2. AMENDMENT/MODIFICATION NO. 0002	3. EFFECTIVE DATE 9/27/01	4. REQUISITION/PURCHASE REQ. NO.	5. PROJECT NO. <i>(If applicable)</i>
--	-------------------------------------	----------------------------------	---------------------------------------

14. DESCRIPTION OF AMENDMENT/MODIFICATION *(Organized by UCF section headings, including solicitation/contract subject matter where feasible.)*
Sabine-Neches Waterway, Texas, Port Arthur Canal, Junction Area, and Turning Basins in Jefferson County, Texas, Dredging
 (See Attached)

1. The specifications and drawings for Invitation No. DACW64-01-B-0033, Dredging, Port Arthur Canal, Junction Area, and Turning Basins in Jefferson County, Texas, Sabine-Neches Waterway, Texas, advertised 4 September 2001, and for which bids are rescheduled to be opened on 10 October 2001, are hereby modified as follows:

**SABINE-NECHES WATERWAY, TEXAS
PORT ARTHUR CANAL, JUNCTION AREA,
AND TURNING BASINS IN JEFFERSON
COUNTY, TEXAS, DREDGING**

**CROSS SECTIONS
PLACEMENT AREA NO.8
STA.196+06.88 TO STA.327+81.33**

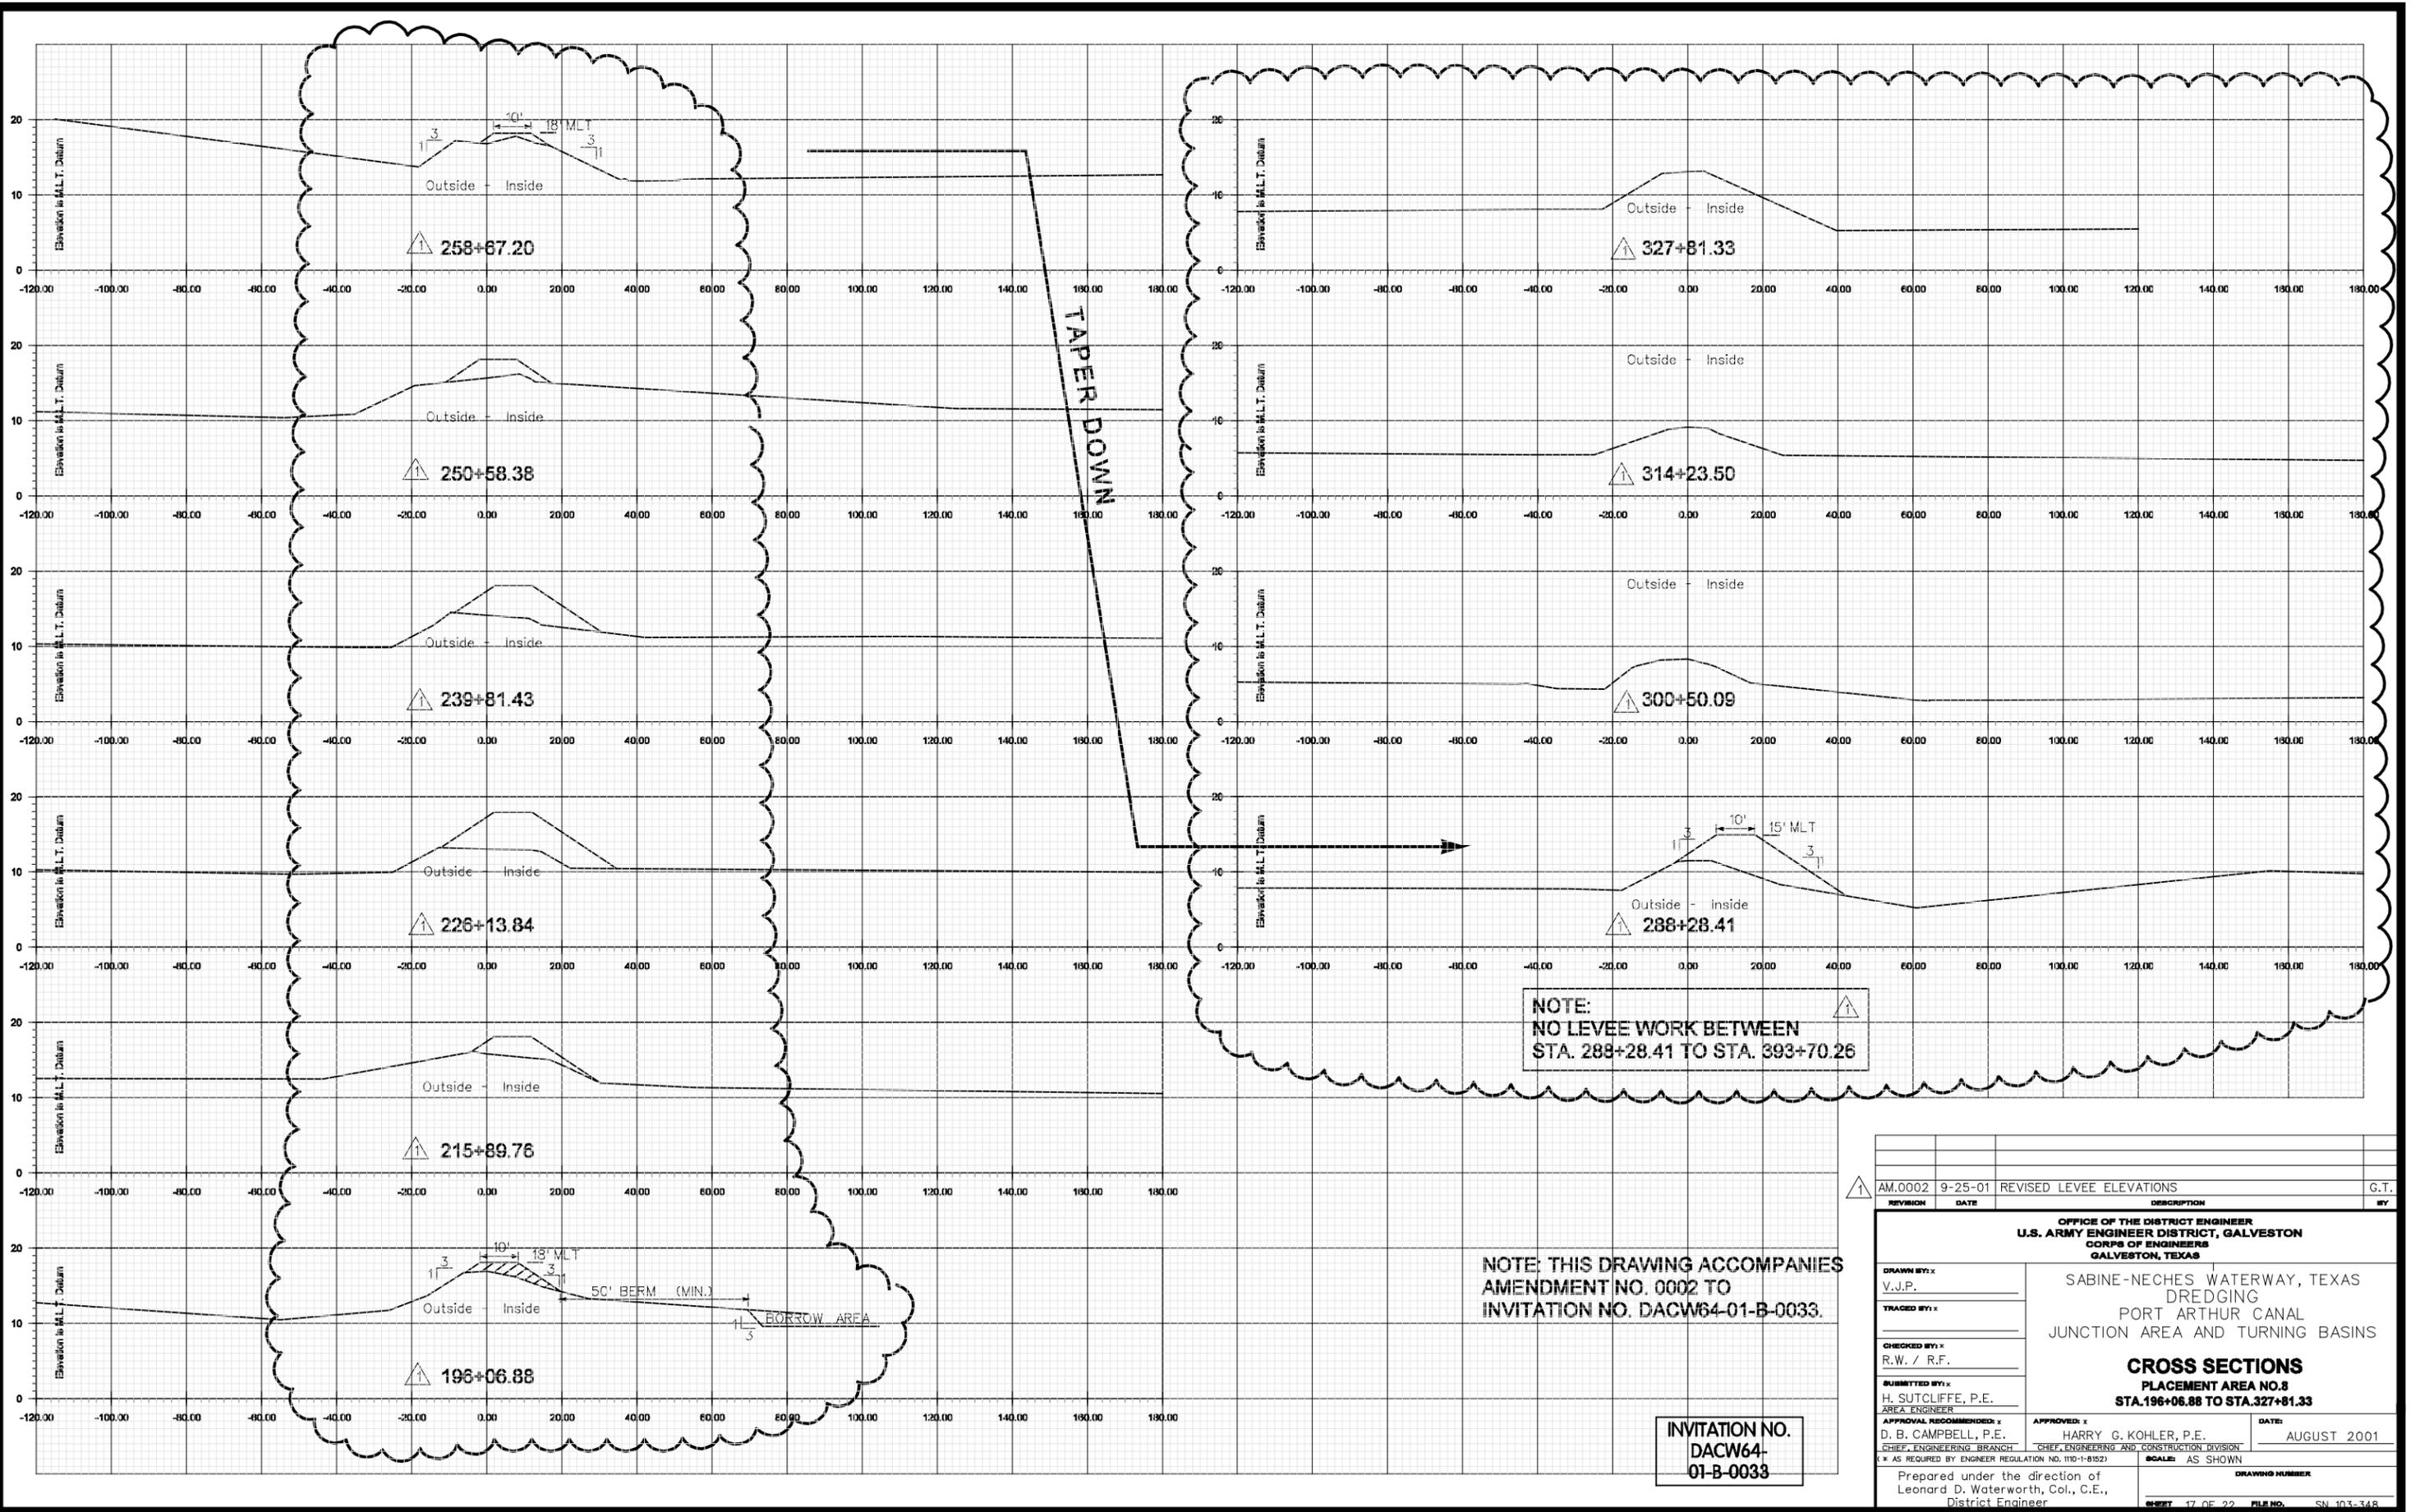
NOTE:
NO LEVEE WORK BETWEEN
STA. 288+28.41 TO STA. 393+70.26

AM.0002	9-25-01	REVISED LEVEE ELEVATIONS	G.T.
REVISION	DATE	DESCRIPTION	BY

**PLAN
PLACEMENT AREA NO. 8
STA. 342+69.32 TO STA. 511+13.94**

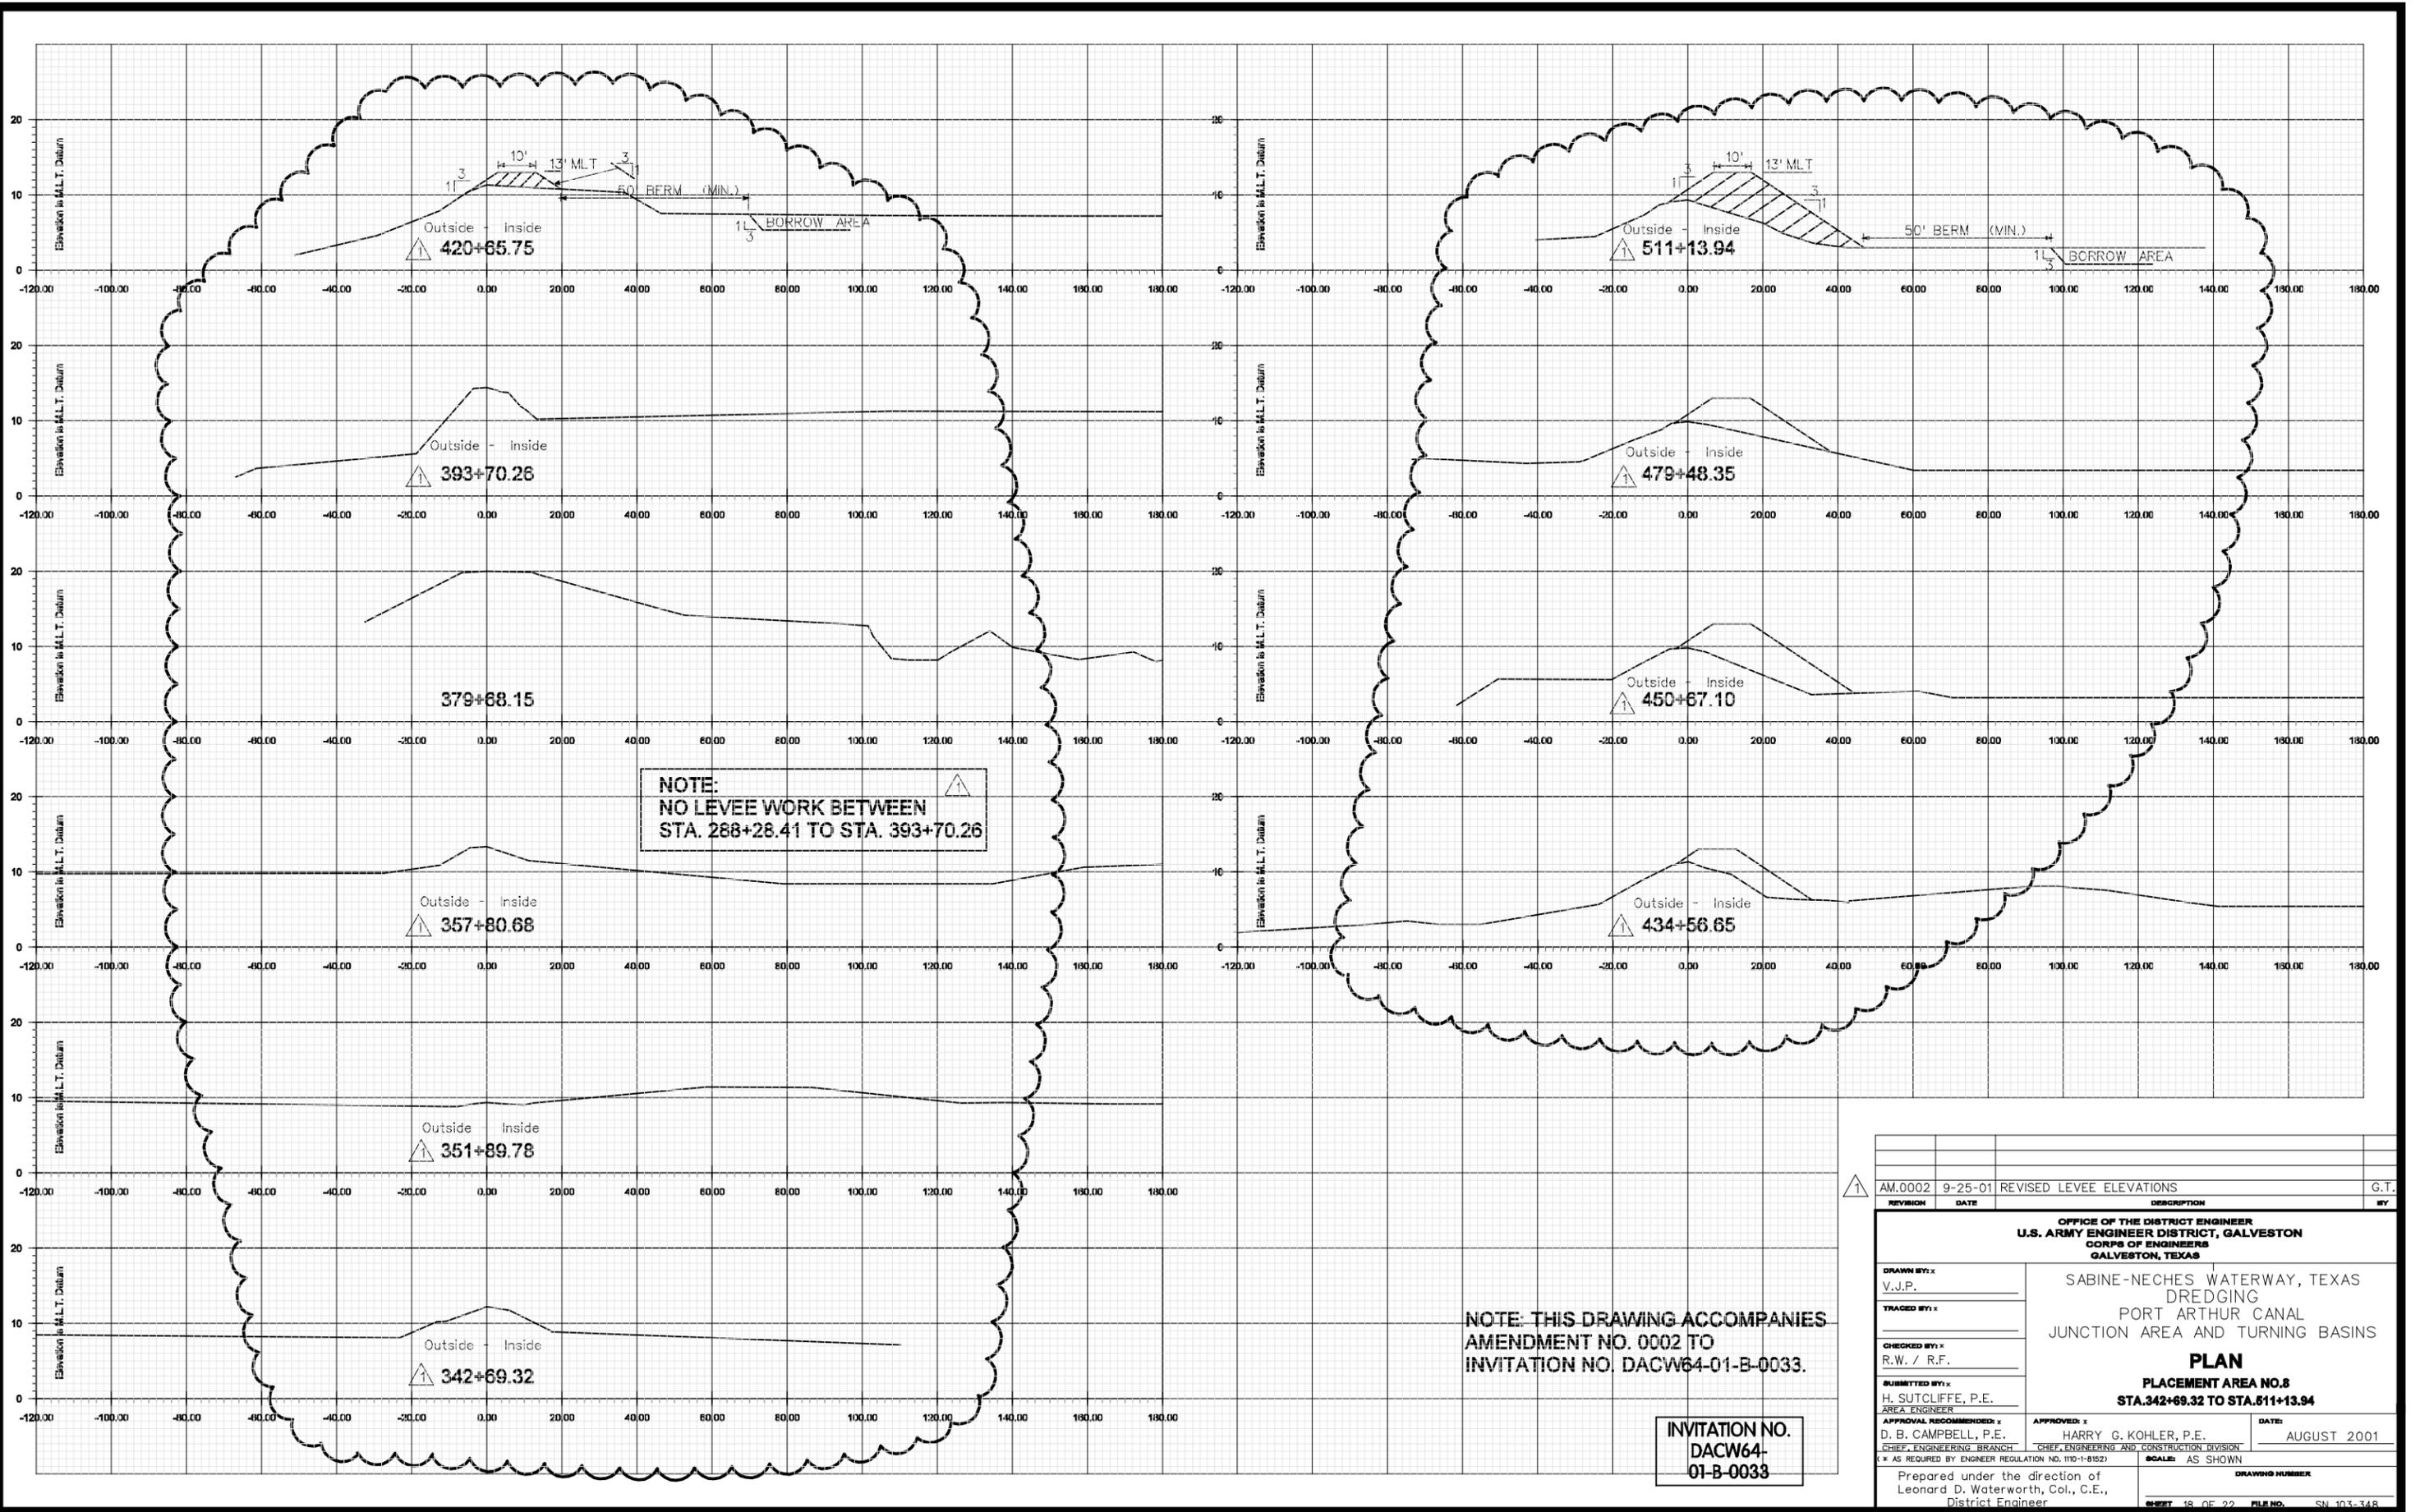
REVISION	DATE	DESCRIPTION	BY
AM.0002	9-25-01	REVISED LEVEE ELEVATIONS	G.T.

**CROSS SECTIONS
 PLACEMENT AREA NO.8
 STA.521+69.46 TO STA.632+13.37**

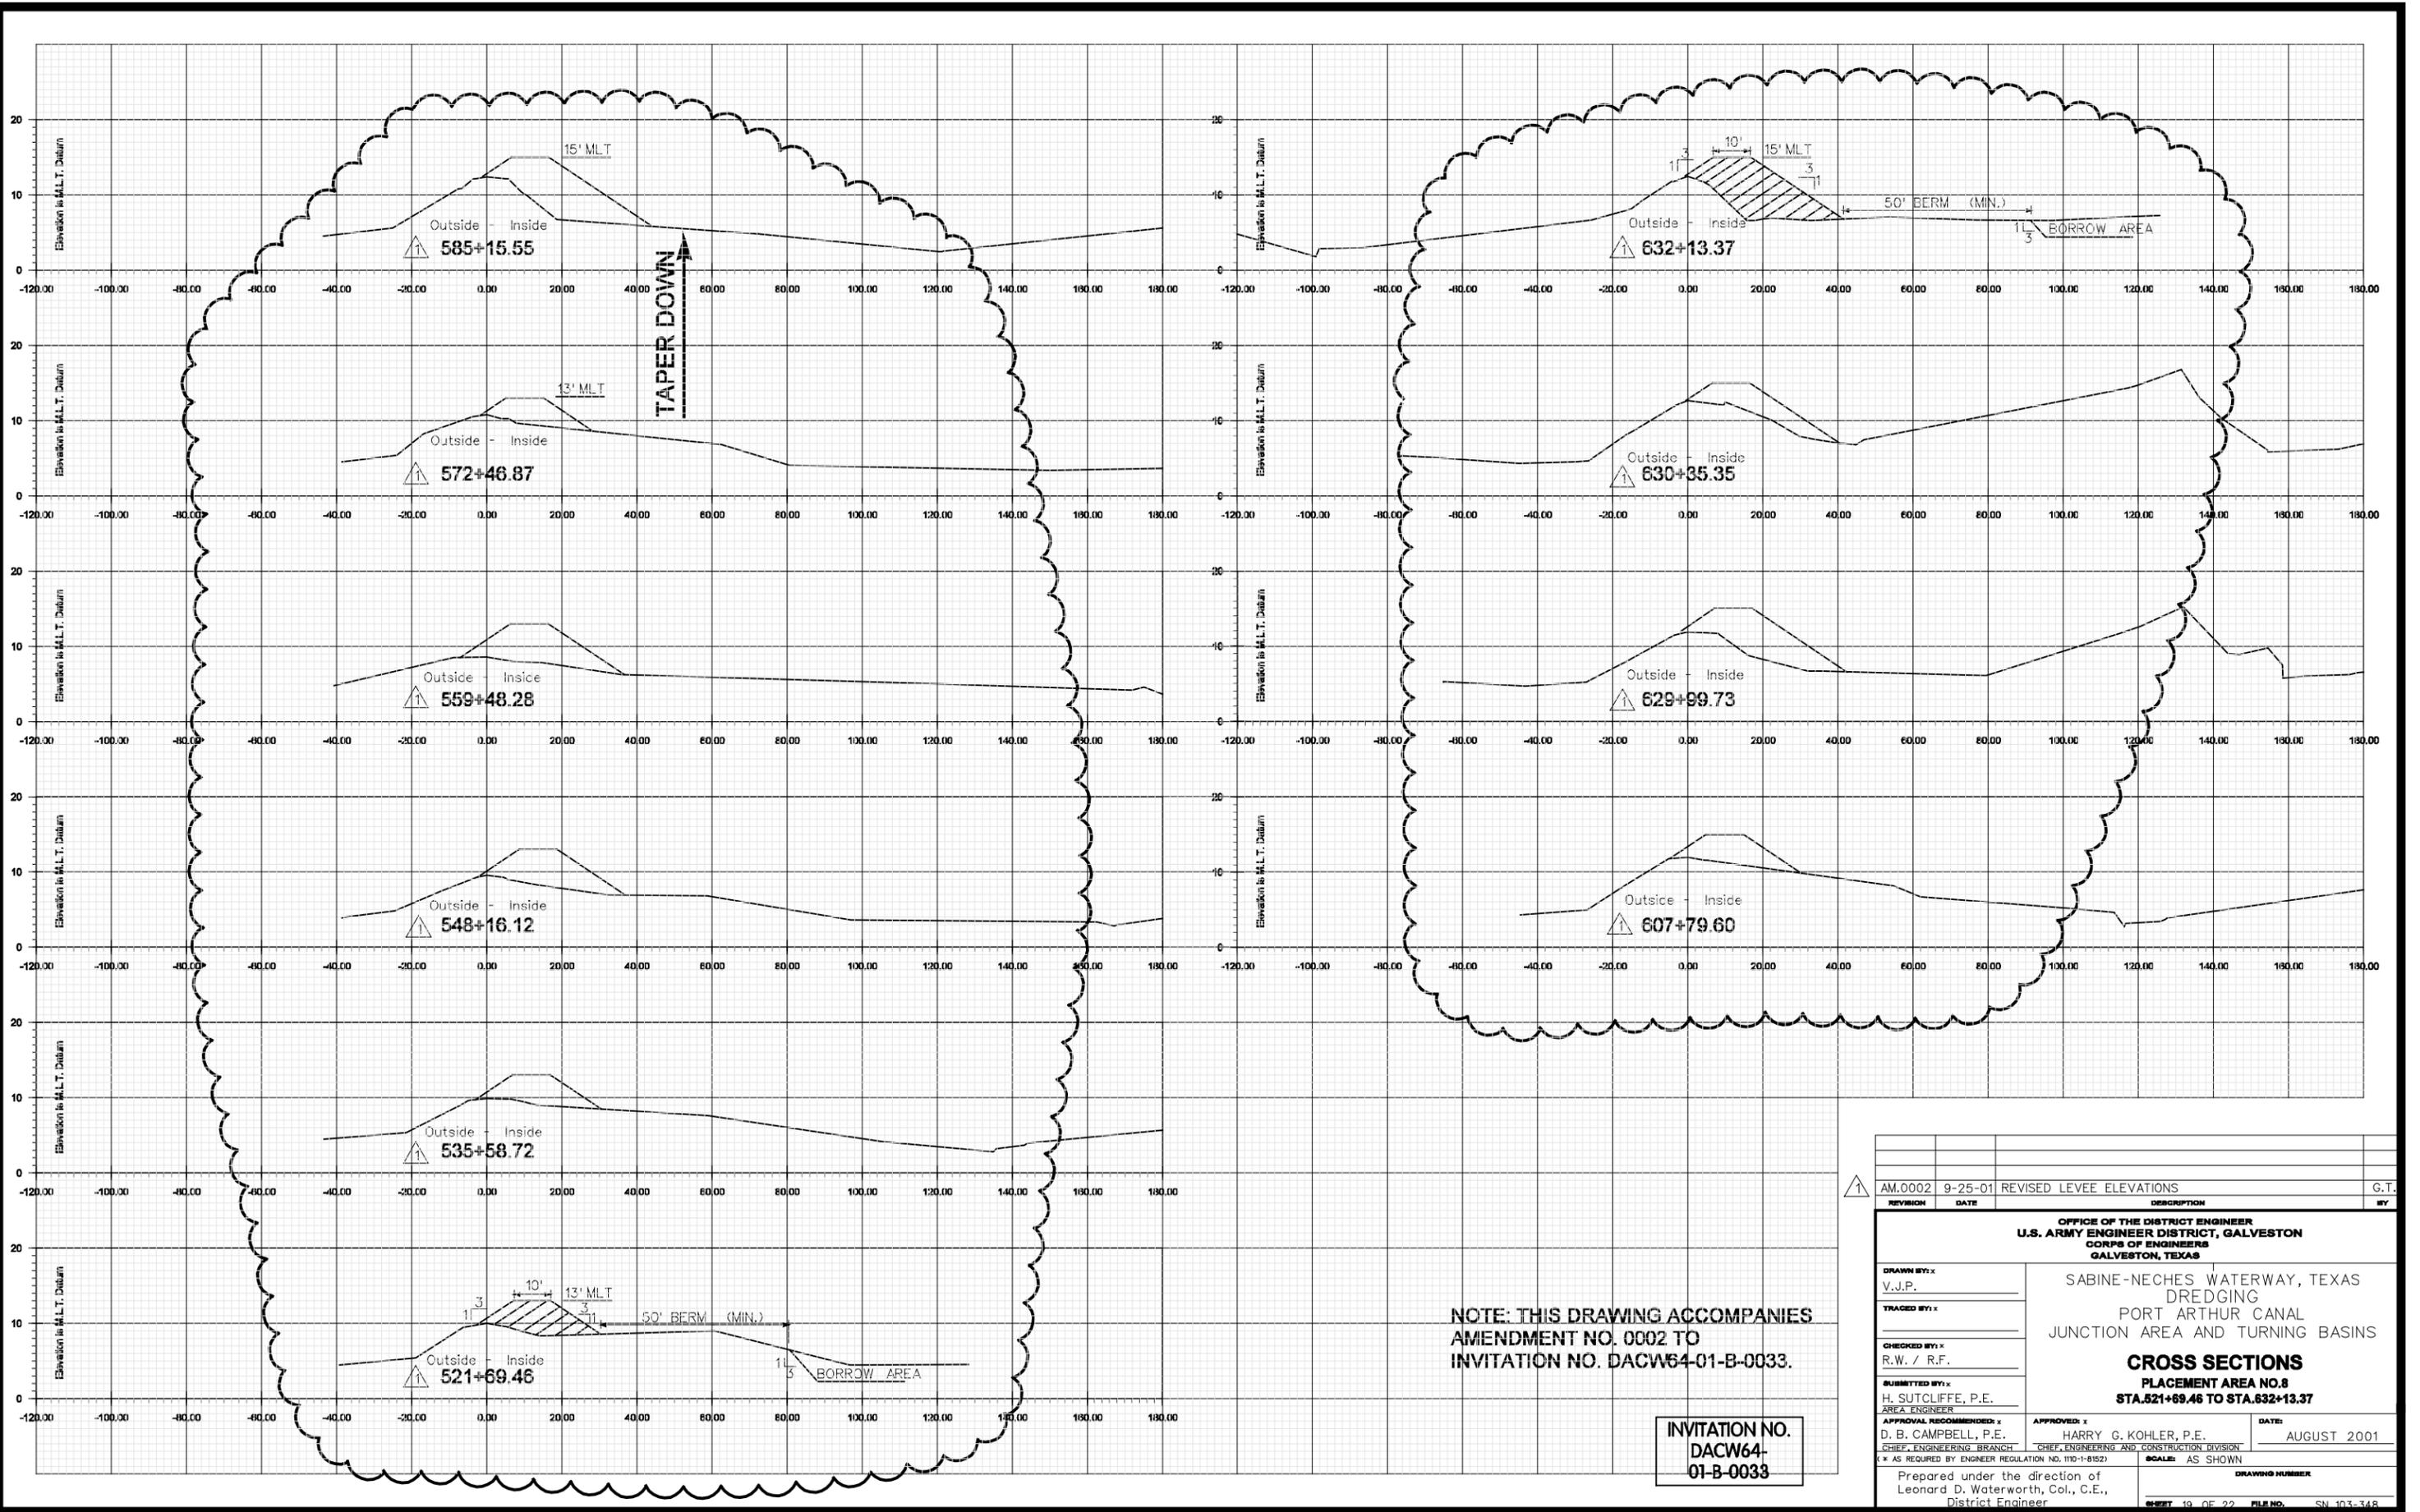
AM.0002	9-25-01	REVISED LEVEE ELEVATIONS	G.T.
REVISION	DATE	DESCRIPTION	BY
